TECHNICAL REVIEW OF PROJECT-SPECIFIC DRILL CUTTING DISPERSION MODELLING FOR TILT COVE EXPLORATION DRILLING PROJECT ENVIRONMENTAL IMPACT STATEMENT

FFHPP is requesting that Science undertake a technical review of the project-specific drill cutting dispersion modelling from the Tilt Cove Exploration Drilling Project, which is appended to the EIS document. In particular, a review of the scientific merit of the information presented and the validity of the Proponent's methodologies and conclusions.

The submission consists of the following document: Appendix C – Suncor Energy Offshore Exploration Partnership Tilt Cove Exploration Drilling Project (2019–2028) Drill Release Risk Assessment.

Figure 1. Scenario 1: Predicted thickness of seabed deposition of discharged mud and cuttings resulting from all drilling sections (top) and from only the riserless drilling sections (bottom) during the summer at EL 1161 (Suncor Energy 2019).

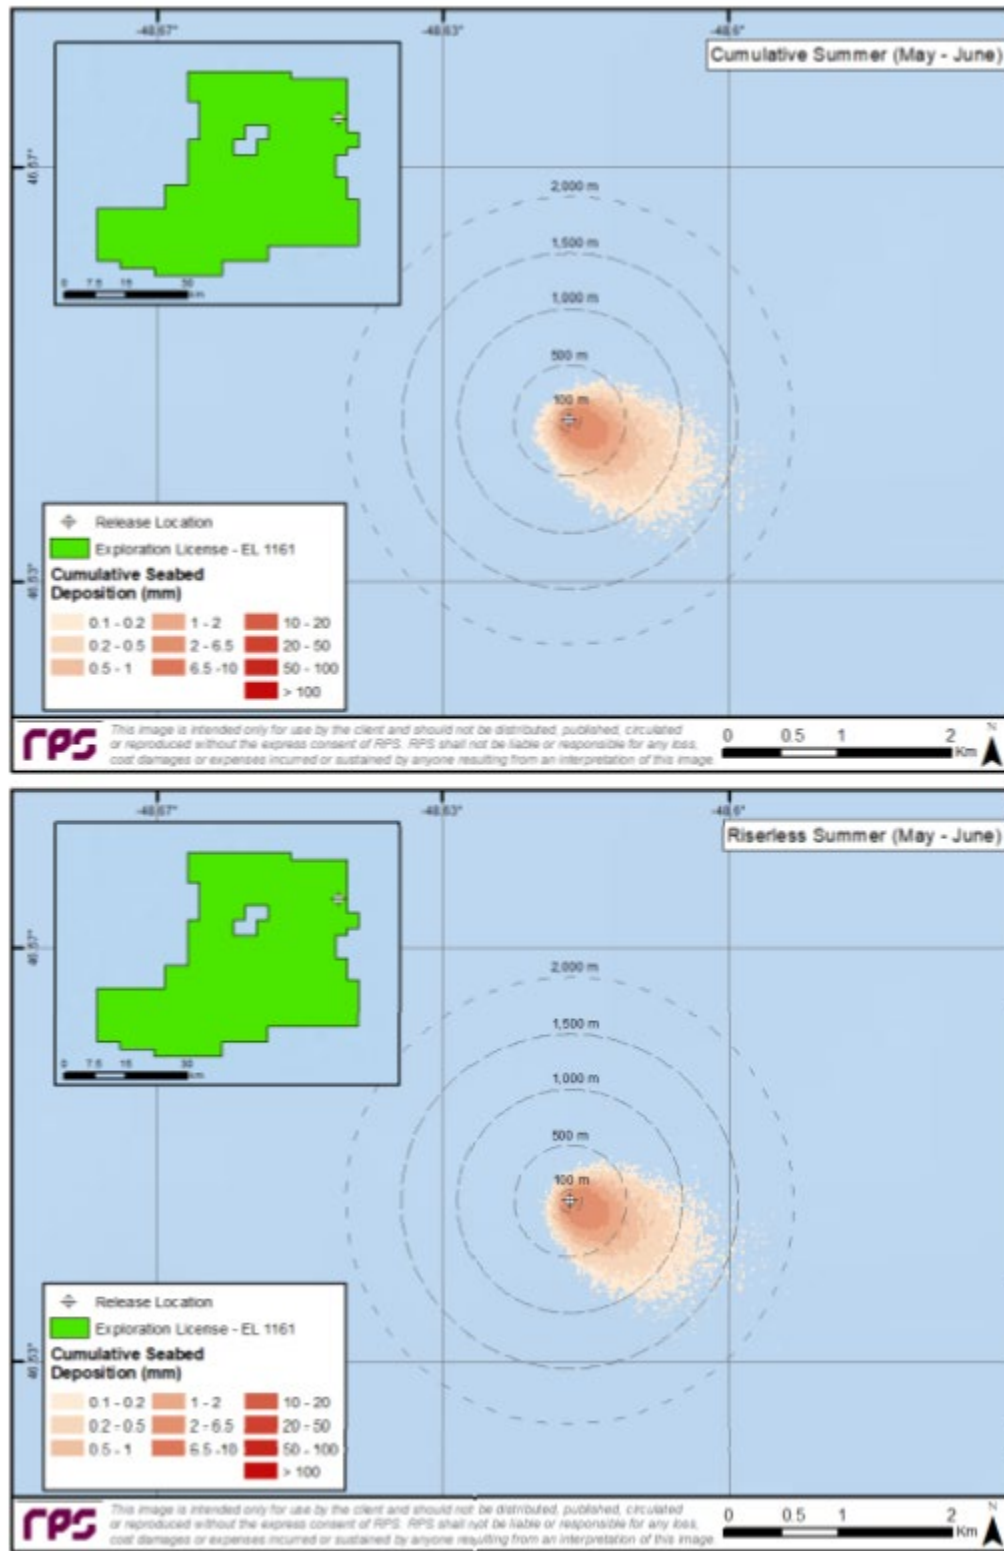
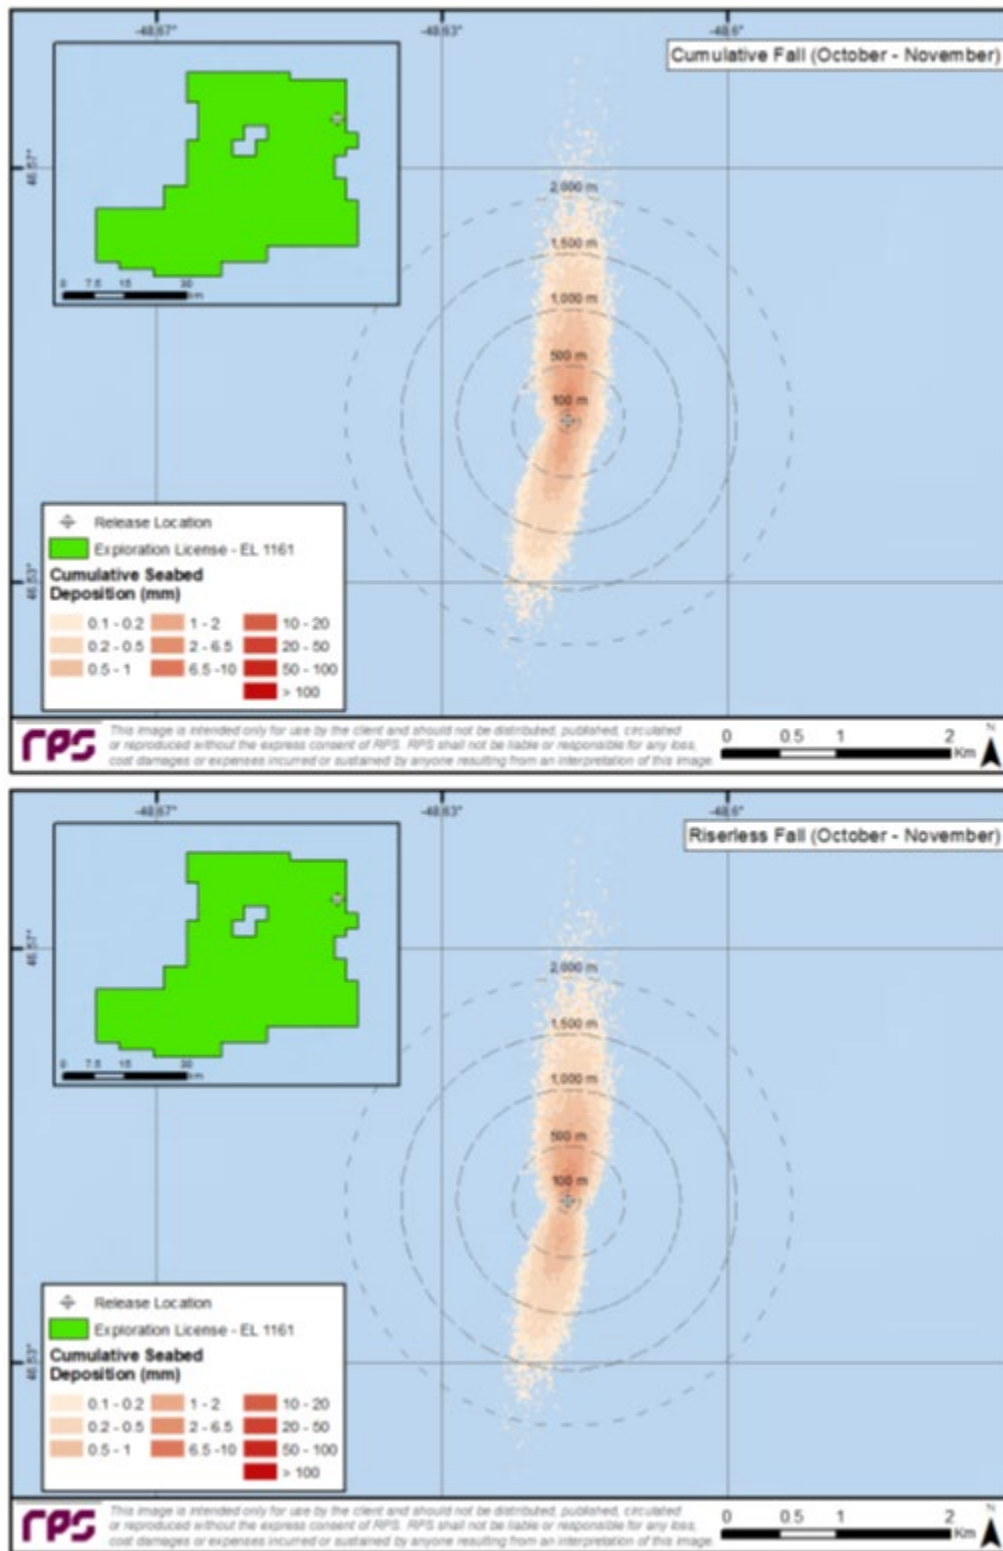
There are issues with the model results. The total deposition during the riserless stages (stage 1 and 2) is more or less identical to the deposition over the 5 stages together (Figures 1 and 2 [Figures 3-1 and 3-2 in Suncor Energy 2019]). This suggests that the sediments from stages 3 to 5 do not deposit at all and that the model loses track of them. This is more or less confirmed on page 16 of Suncor Energy (2019), “*approximately 78% of the total mass of all sections combined are predicted to be discharged near the seabed, where they settle rapidly. During the remaining sections of drilling, where the remaining roughly 22% of mass is discharged near the sea surface, smaller particle size fractions with low settling velocities were transported greater distances as they settled through approximately 100 m of the water column*”. In Table 1 (Table 2-1 in Suncor Energy 2019), the total volume discharges is approximately 10,000 m³ (480 m³ cuttings + 9,831 m³ mud). A simple calculation based on Table 2 ([Table 3-1 in Suncor Energy 2019] deposition thickness x surface area) suggests that the total volume of material deposited in the model varies between 1,350 m³ (minimum approximation) and 2,800 m³ (maximum approximation). This appears to imply that only 13.5–28% of the particle volume actually deposits according to the model. The consequences of the model not accounting for this fraction of sediment should be addressed.

Figure 3. Average surface current speed (cm/s) in color, and speed and direction presented by red vectors offshore Newfoundland from HYCOM (2006–12). The black X represents the EL 1161 drilling site (Suncor Energy 2019).

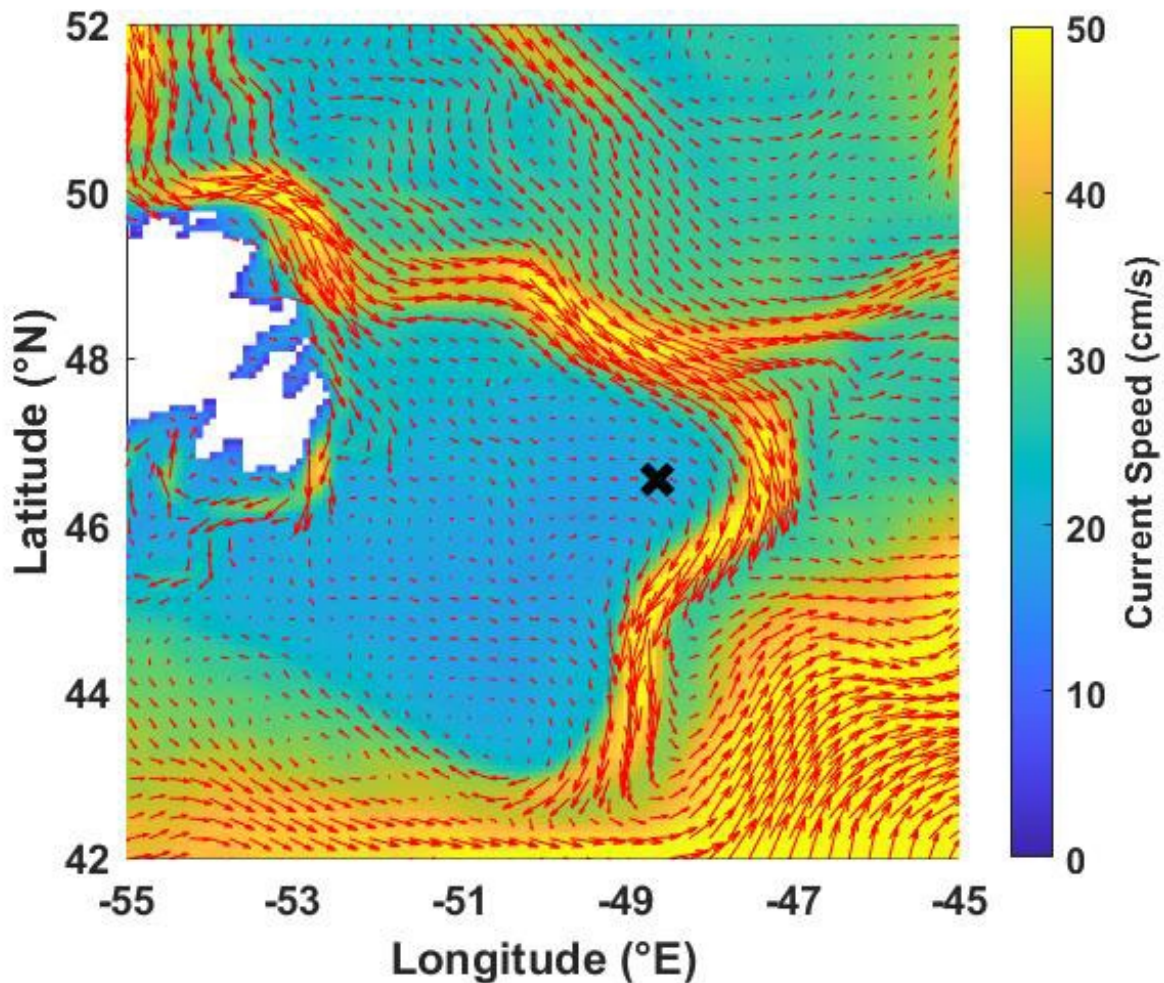
Section 1.2, paragraph 3: Figure 3 (Figure 1-3 in Suncor Energy 2019) “...illustrates that the site is close to the inshore branch of the Labrador Current near the Flemish Cap”. This is not the definition of the inshore branch, which is usually defined as the current flowing along the NL coast (in contrast with the main branch of the Labrador current that flows on the continental shelf break). The inshore branch further splits north of the Avalon Peninsula with part of the flow merging offshore with the main branch of the Labrador current and the remaining flowing through the Avalon channel near St. John’s.

Figure 4. Monthly average (grey solid) and 95th percentile (orange dashed) HYCOM surface current speed (cm/s) statistics at EL 1161 (Suncor Energy 2019).

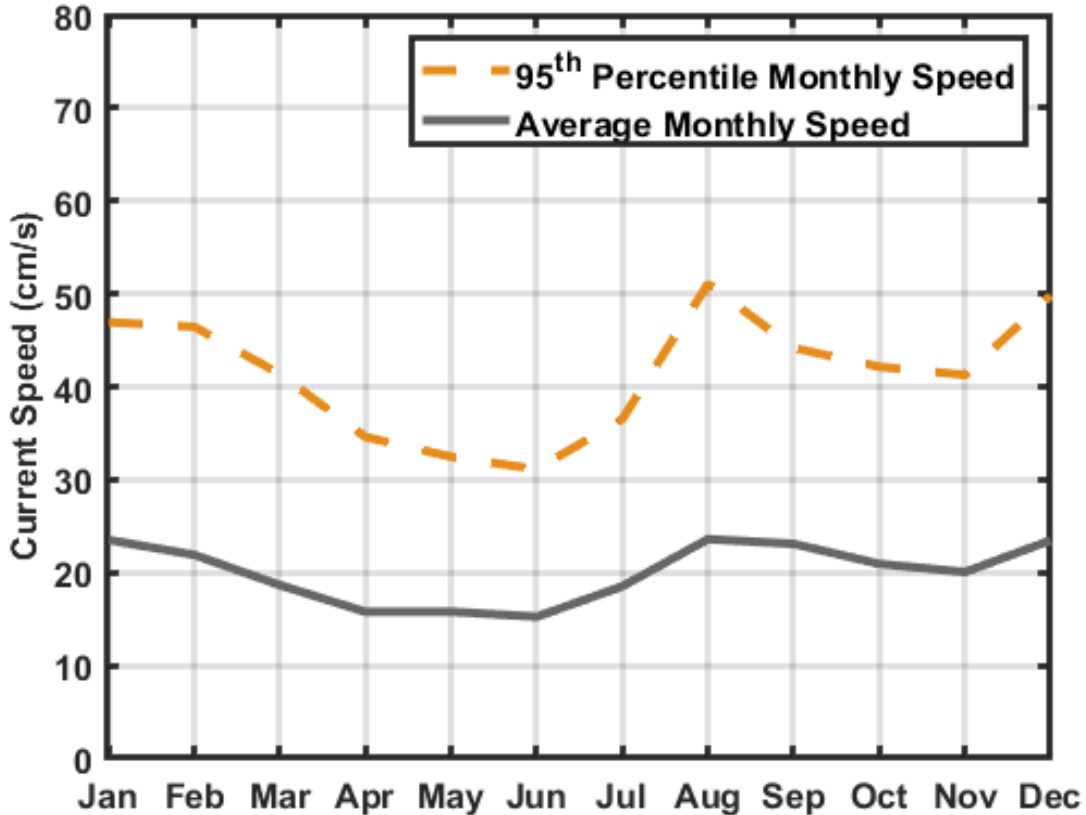
Figure 4 (Figure 1-5 in Suncor Energy 2019): The authors describe the surface currents in the model, however, the bottom currents and subsurface currents are much more relevant in this study (see page 21, paragraph 2 of Suncor Energy [2019], “Summer simulations for the EL 1161 site were predicted to have weaker subsurface current regimes with moderate directional

variability, when compared to the fall simulations”). As such, using the surface currents to analyze the variability in the environment is not applicable for this study.

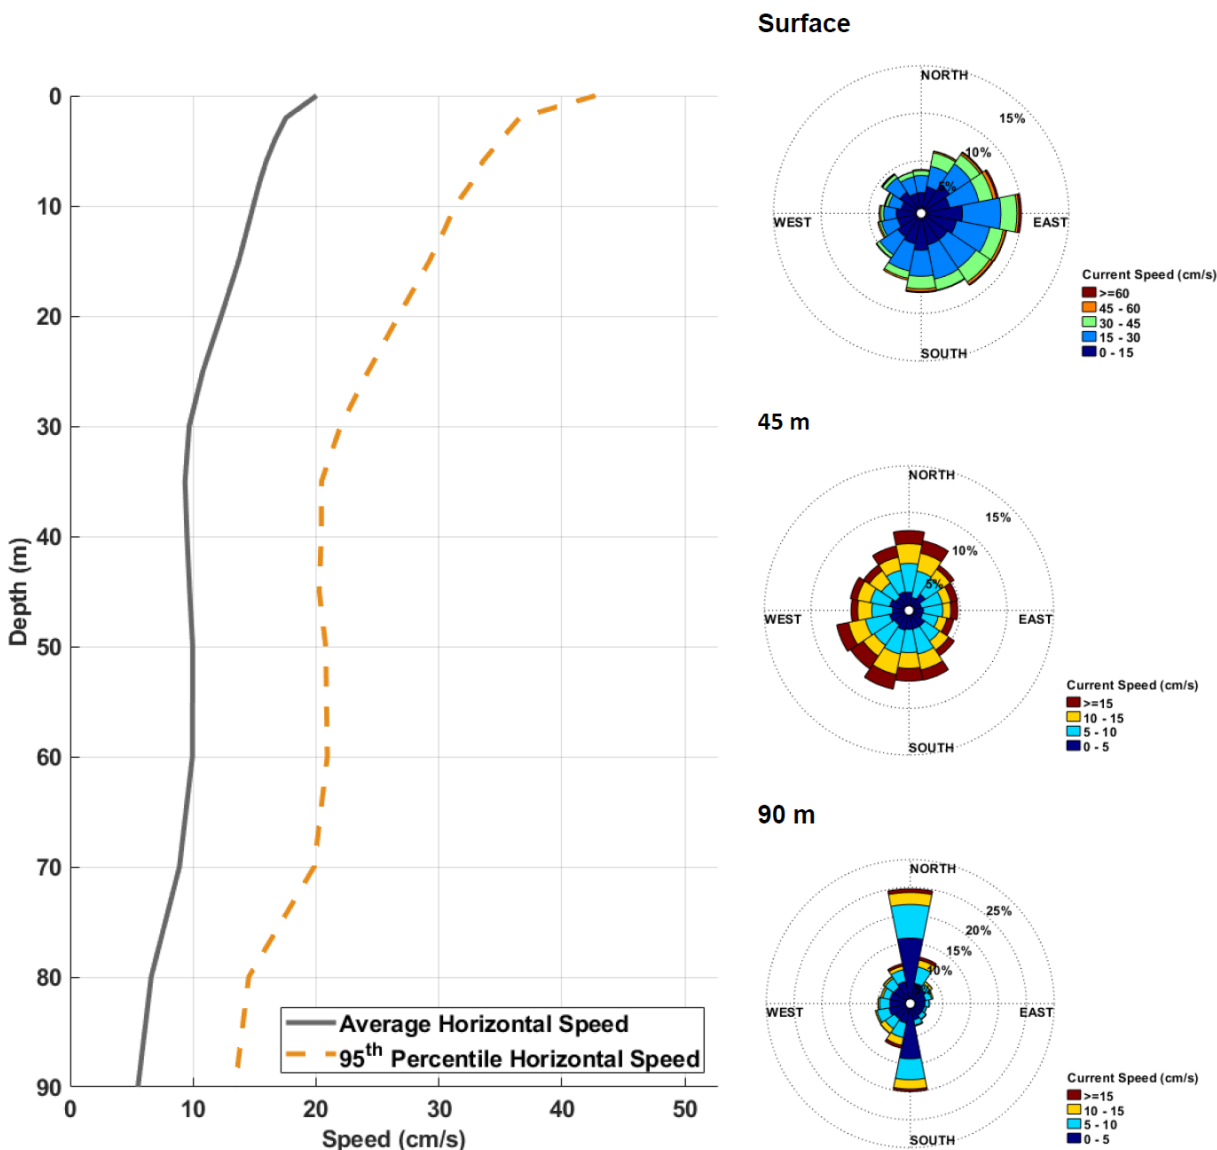
Figure 5 (Figure 1-6 in Suncor Energy 2019): A subject matter expert commented that the current rose at 90 m is quite different than higher in the water column. This may be important for the simulation. The text says that the proposed drilling site is 100 m deep, however the HYCOM currents displayed in this figure only extend to 90 m. The currents in the bottom 10 m are unknown, however, and important for deposition simulations. This is another situation where it is important to describe the vertical grid spacing so that readers can understand how well the bottom boundary layer is resolved. Also of note, fall data in Figure 2 (Figure 3-2 in Suncor Energy 2019) match with the deep current rose (Figure 5), but summer data in Figure 1 (Figure 3-1 in Suncor 2019) are more similar to the surface rose (Figure 5). Further explanation or investigation for this was not included in the appendix.
